PROJECT : BD3G
Quanta Computer Inc.

Size	Document Number	Rev
	DDR2 SODIMMS TERMINATIONS	1A
Date:	Thursday, May 29, 2008	Sheet 8 of 42

Size	Document Number	Rev
	RS740/RS780-HT LINK I/F 1/5	1A
Date:	Thursday, May 29, 2008	Sheet 9 of 42

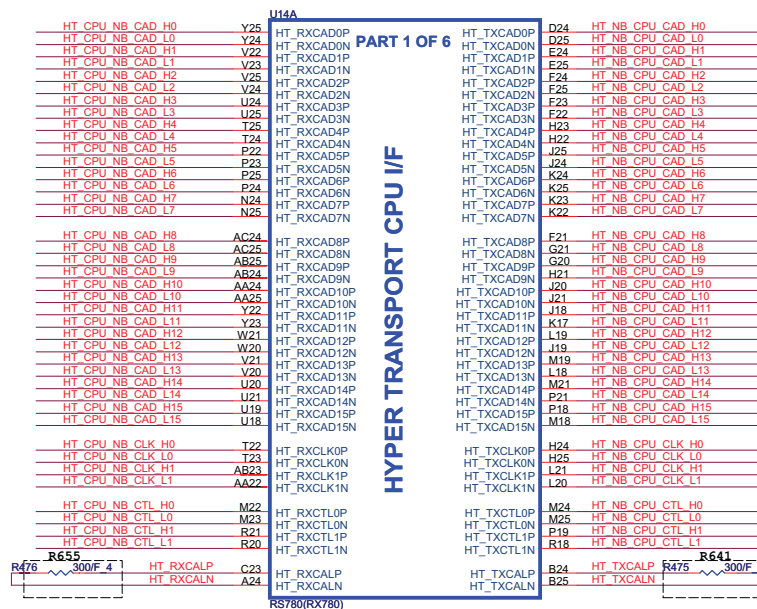
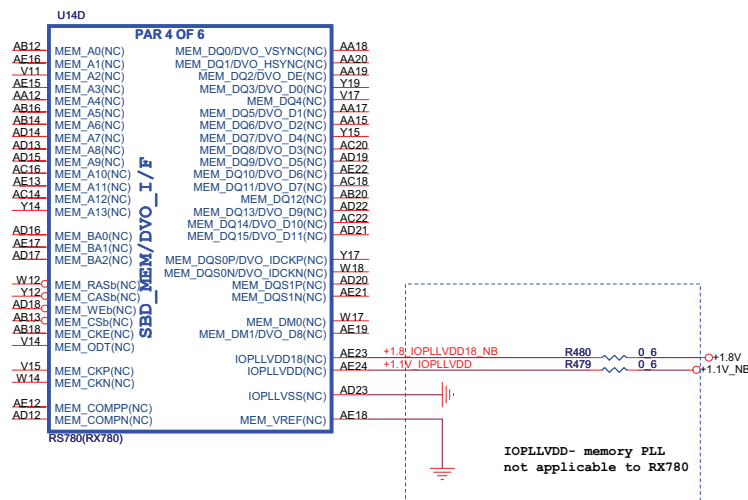
11/4 modify

This block is for UMA RS780 only , RX780 can
remove all component

signals	RS780	RX780
HT_TXCALP	R641 300 ohm 1%	R641 1.21k ohm 1%
HT_TXCALN		
HT_RXCALP	R655 300 ohm 1%	R655 1.21k ohm 1%
HT_RXCALN

Size	Document Number	Rev
	SB700-SATA/IDE/HWM/SPI 3/4	1A
Date:	Thursday, May 29, 2008	Sheet 15 of 42

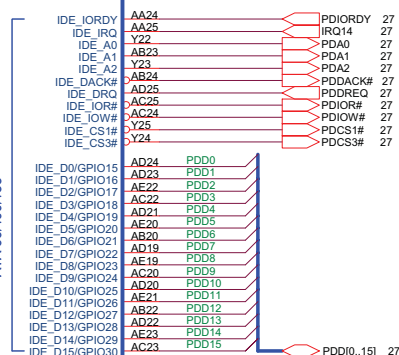
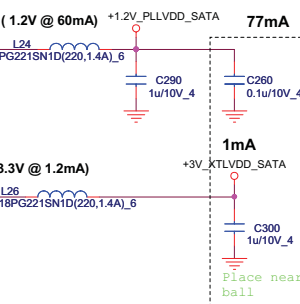
2/22 change SATA ODD from port3 to port4 (solve ODD
post detect fail)

12/4 change BOARD ID3 from GEVENT7 to GPIO48

2/13 EMI
stuff C375, C366 for SB HW MONITOR

NB/SB POWER GOOD CIRCUIT

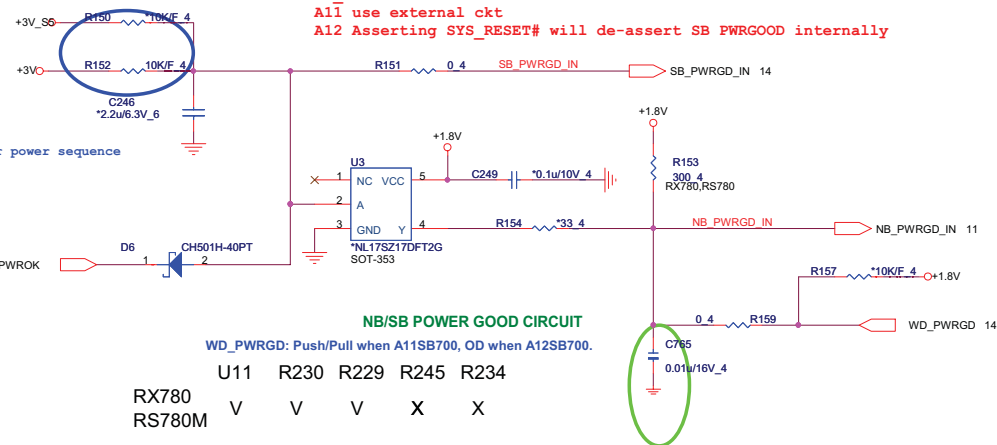
4/10 change R150 to R152 for power sequence

4/24 stuff C765 10nf to meet power sequence

CRT PORT

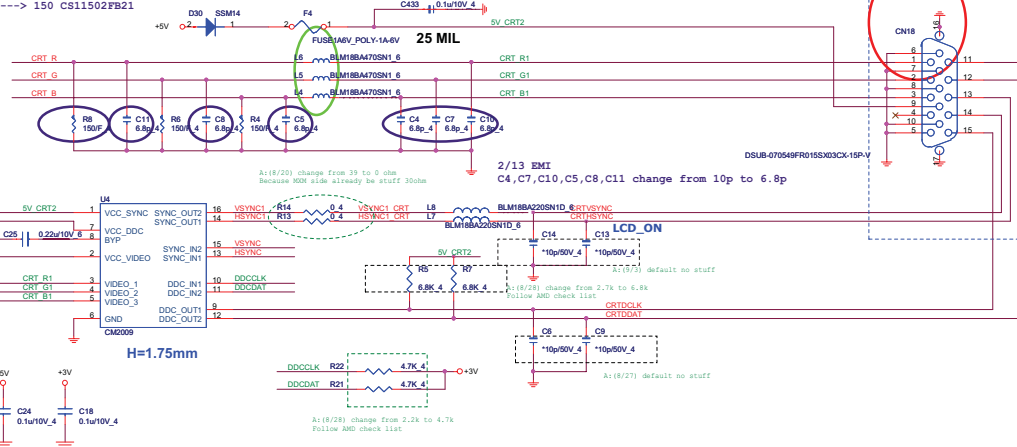
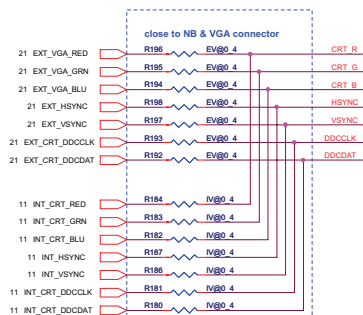
2/1
RS780M A13 R8 ---> 140 CS11402FB19
MOM R8 ---> 150 CS11502FB21

1/31 EMI Change L4,L5,L6 from CX0HM121008 to CX8BA470003

10/12 fix CRT connect error

2/10 DEL D4,D5 footprint and DEL
CRT_SENSE# net

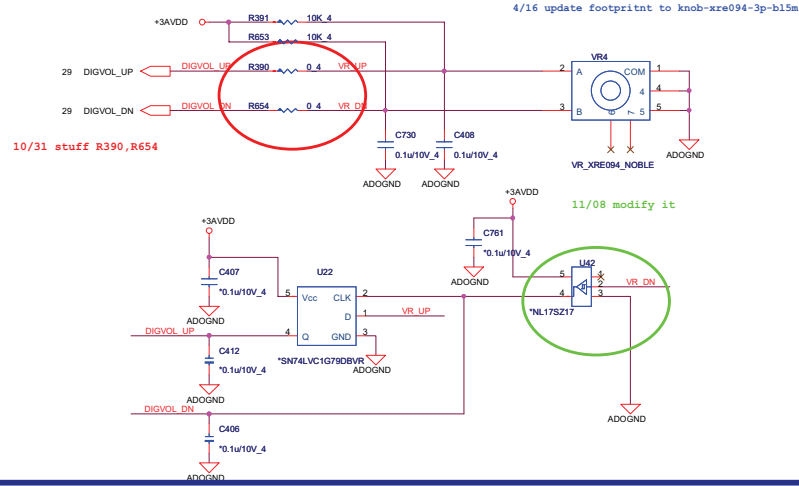
12/07 Solve Audio issue: When plug in-out headphone, headphone has no sound.
1. Change R652&R651 to C763, C764 (100/6.3V 0603)

2/5 Change R714, R715 from 10uF to 0 ohm (Audio HP circuit)

12/20 solve GPRS noise
1. stuff R386/R387/C404/C405 to 0.1u
2. Change L44/41 to BK1608LL121
3. reserve C786/C787 to adj noise

Size Document Number
OZ129T (Card Reader/1394)
Date: Thursday, May 29, 2008 Sheet 26 of 42 Rev 2A

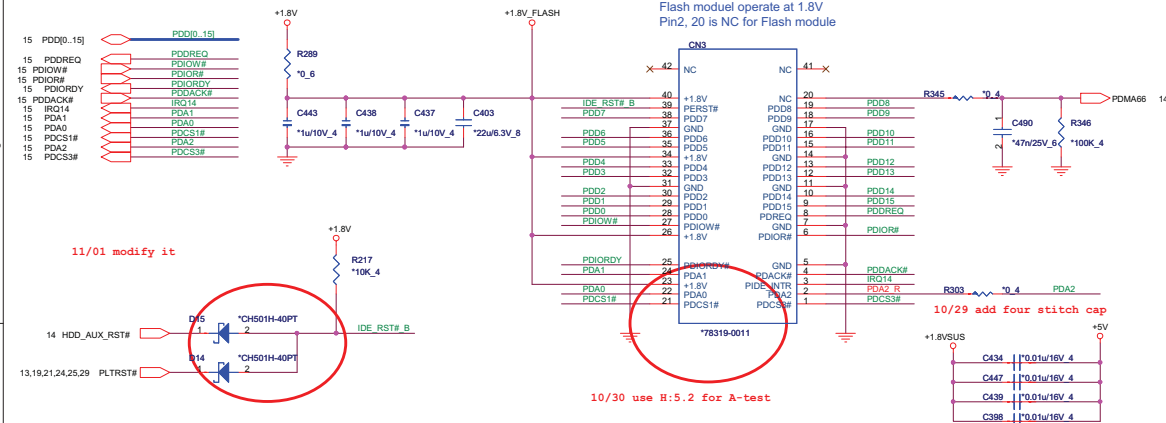
12/21 EMI
R308-R329 0ohm(CS00002JB38) change to 33ohm(CS03302JB29)

12/21 EMI
Don't stuff RN34, RN35 (CJ000042N12)
Add L68, L69 (CX0900JT005)

These 1394 signals are high speed differential pairs and must be kept equal length with a differential impedance (Z0) of 110ohms.

**ESATA**

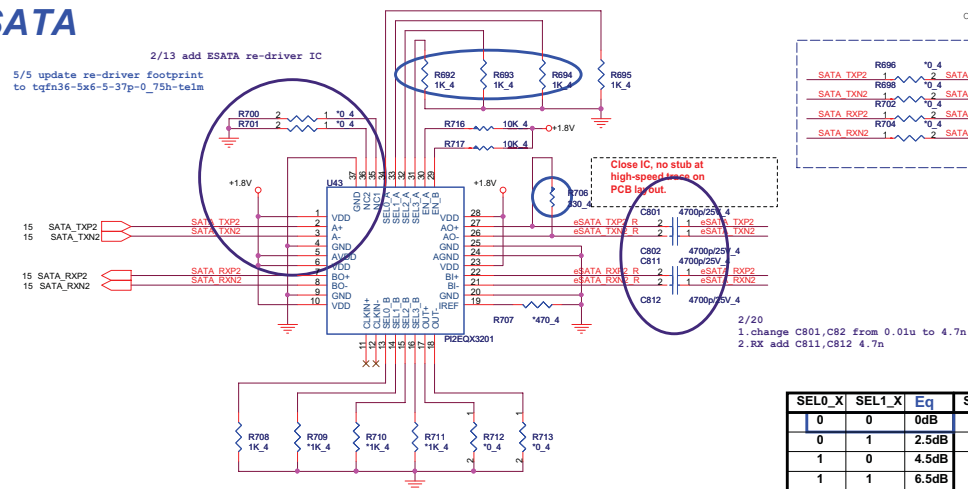
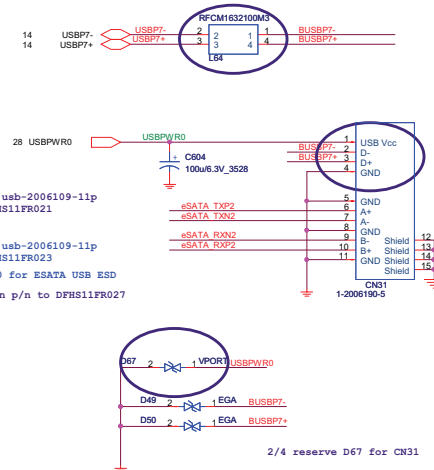
2/13 add ESATA re-driver IC
5/5 update re-driver footprint
to tqfn36-5x6-5-37p-0 75h-te1m

2/26 change ESATA conn usb-2006109-11p
update p/n to DFHS11FR021

4/10 change ESATA conn usb-2006109-11p
update p/n to DFHS11FR023

4/10 add D67,D49,D50 for ESATA USB ESD
5/29 change ESATA conn p/n to DFHS11ER02

2'nd SATA HDD

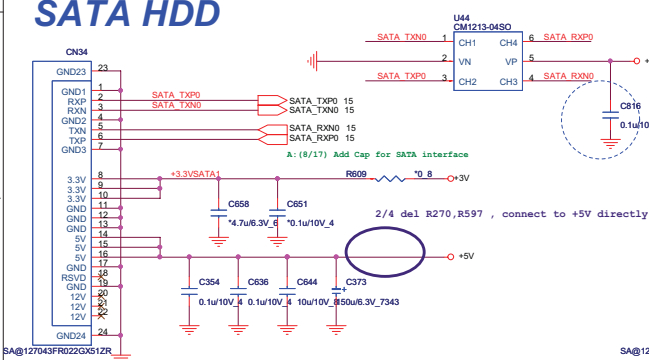
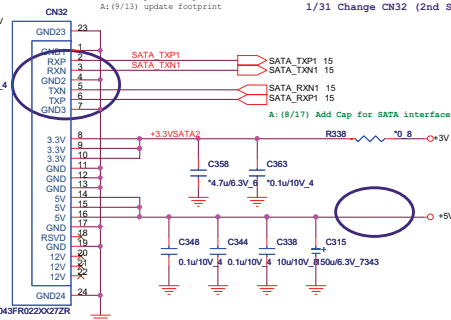
1/17 Change CN32 (2nd SATA CONN) from DFHS22FR064 to DFHS22FR094

1/17 Change CN32 footprint from SATA-127043FR022XX27ZR-22P-L-H to SATA-127043FR022G285ZR-22P-L

1/31 Change CN34 (1st SATA) P/N from DFHS22FR063 to DFHS22FR082

1/31 Change CN32 (2nd SATA) P/N from DFHS22FR094 to DFHS22FR083

4/17 remove D82~D86 for CN32 , change to U45 CM1213-04SO

5/5 add C818 0.01u to U45 +5V for ESD

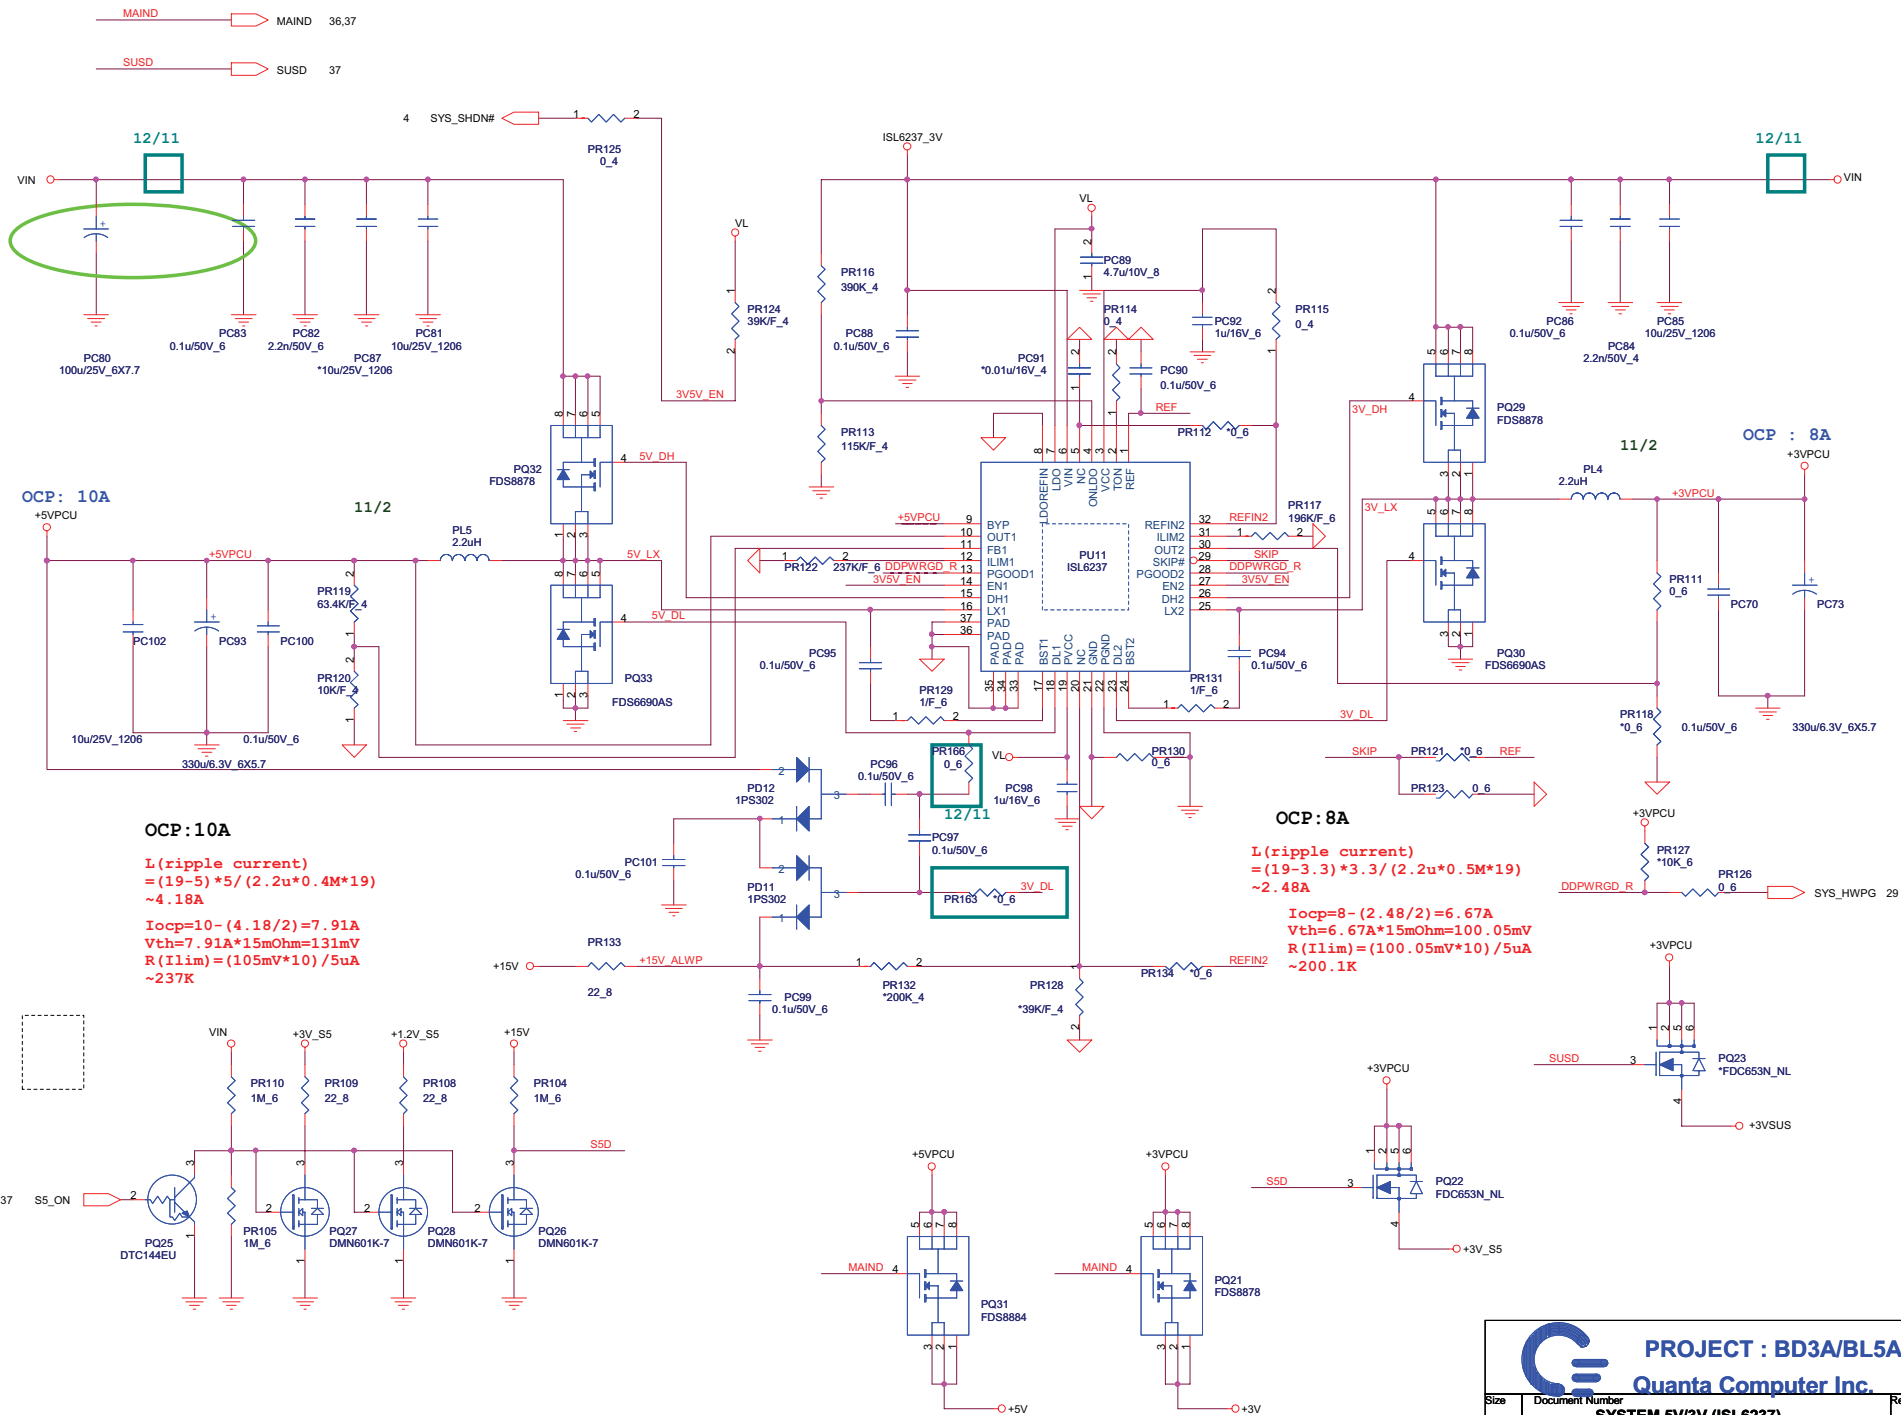
11/2 Input sense resistor and Constant power setting table

$$LIM = (1/R2) * (((0.05/VREF=2.39)VACLIM)+0.050)$$

$$CURRNT LIMIT POINT = (90w/19v) * 0.85 = 4.026A$$

$$4.026A = (1/0.02) * ((0.05/2.365)VACLIM+0.05)$$

$$VACLIM = ((33/(152)) / ((33/(152)+19.6/(152))) * Vref$$
